STAFF REPORT  
TRUE NORTH SUBDIVISION  
SUBDIVISION S 1-24  
April 10, 2024

**Subject: ENGINEERING COMMENTS FOR S 1-24 PRELIMINARY PLAT “TRUE NORTH” SUBDIVISION**

# TRUE NORTH SUBDIVISION

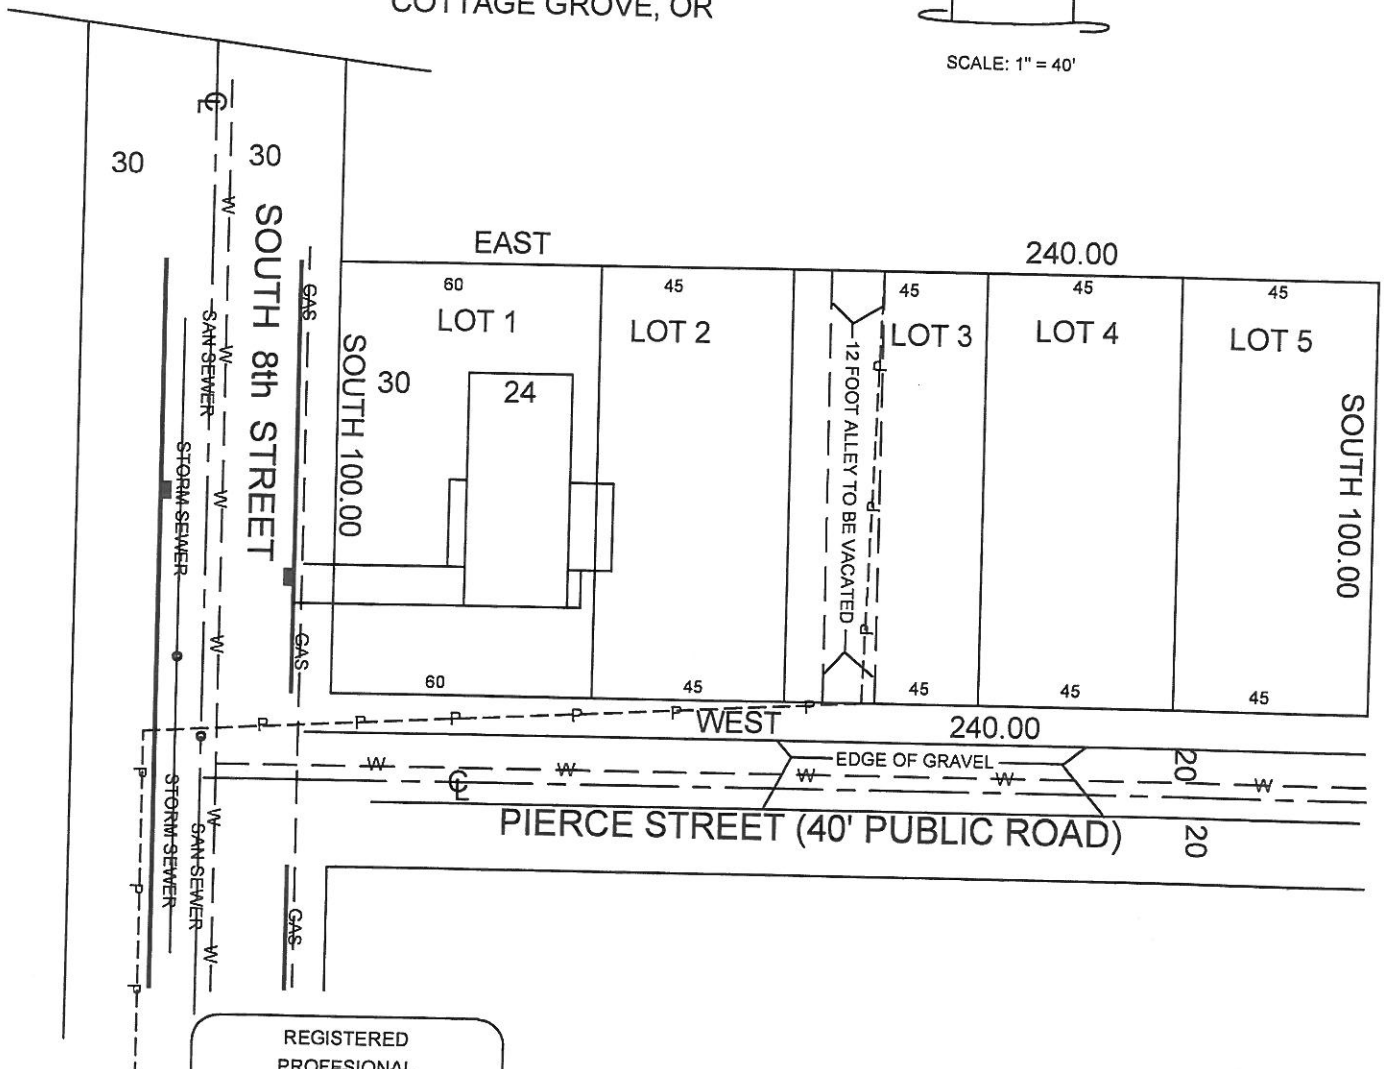
As a condition of approval, a 7ft public utility easement (PUE) is required along the southern boundary of the proposed lots. Additionally, a 10ft easement (PUE) will be required between lots 2 and 3, or 3 and 4 for PP&L.

10. The existing structure crosses the proposed rear property line. Prior to final plat submittal and approval, the applicant must demonstrate how the existing structures meet required setbacks (5ft rear setback for structures 16ft or less in height).

- An alley style street cross-section is appropriate for this development. Paving to City Standard is required at 18’ wide with drainage to the center of the paving to a professionally designed storm sewer system.

- There is an 8” water main located in Pierce Ave.
- Developer is required to install backflow devices on all water services.

- A sanitary sewer extension will be required in Pierce Avenue flowing west to South 8<sup>th</sup> Street.
- Per DEQ Rules any sanitary sewer service that serves two or more dwellings must be a public facility. Depending on the proposed design of the sanitary sewer collection facilities an easement granted to the City may be required (14’ wide).
- Public facilities shall be designed by a licensed Professional Engineer and meet City Standards.

- There are storm drainage facilities in South 8<sup>th</sup> Street the alley style street shall be designed to collect and drain to the west into that system.
- Stormwater calculations shall be completed by a licensed Professional Engineer.
- Storm water runoff may not adversely affect adjacent property owners; therefore no overland flow is allowed.
